Access Compliance Report

Public Rights-of-Way

Intersection ID: 18026	Main Street: E_INDEPENDENCE_BV	Cross Street: WALLACE_LN	Location: SE
ADA ID: 6069B4F5D67F	Ramp Type: ParaDiag	Initial Pass/Fail: Fail	Overall Compliance: No
Severity Score: 13.75			
Codes/Mitigation Info/Possible Solution		Field Measurements/Component Compliance

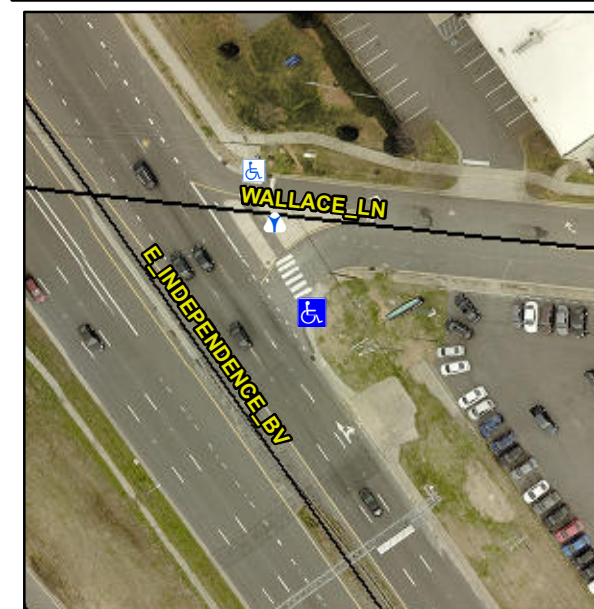
RT RP < 5%

R304.3.2, R304.5.3

Compliance	Description	Data	Compliance	Description	Data
N/A	Ramp Length LT (in)	65.0	N/A	Ramp Length RT (in)	68.0
Yes	Ramp Width LT (in)	51.0	Yes	Ramp Width RT (in)	53.0
No	Ramp Slope LT (%)	8.7	Yes	Ramp Slope RT (%)	3.7
No	Ramp XSlope LT (%)	2.2	Yes	Ramp XSlope RT (%)	1.0
N/A	Landing Length (in)	N/A	N/A	DWS Provided?	N/A
N/A	Landing Width (in)	N/A	N/A	DWS Contrast?	N/A
N/A	Landing Slope (%)	N/A	N/A	DWS Length (in)	N/A
N/A	Landing X Slope (%)	N/A	N/A	DWS Full Width?	N/A
N/A	Landing Curb? (Y/N)	N/A	N/A	DWS Offset (in)	N/A
N/A	Shared Landing?	N/A			
N/A	Gutter Ponding?	N/A	N/A	Gutter Slope (%)	N/A
N/A	Gutter Lip Ht (in)	N/A	N/A	Gutter X Slope (%)	N/A
N/A	Painted X Walk1?	Yes	N/A	Painted X Walk2?	No
	X Walk 1 Direction	To NW		X Walk 2 Direction	To SW
N/A	X Walk 1 Width (in)	120.0	N/A	X Walk 2 Width (in)	N/A
	X Walk 1 Slope (%)	3.0		X Walk 2 Slope (%)	2.7
	X Walk 1 X Slope (%)	0.9		X Walk 2 X Slope (%)	3.6
N/A	Ramp inside XWalk1?	Yes	N/A	Ramp inside XWalk2?	N/A

Remove & Replace Curb Ramp With Two New Directional Ramps or Equivalent.
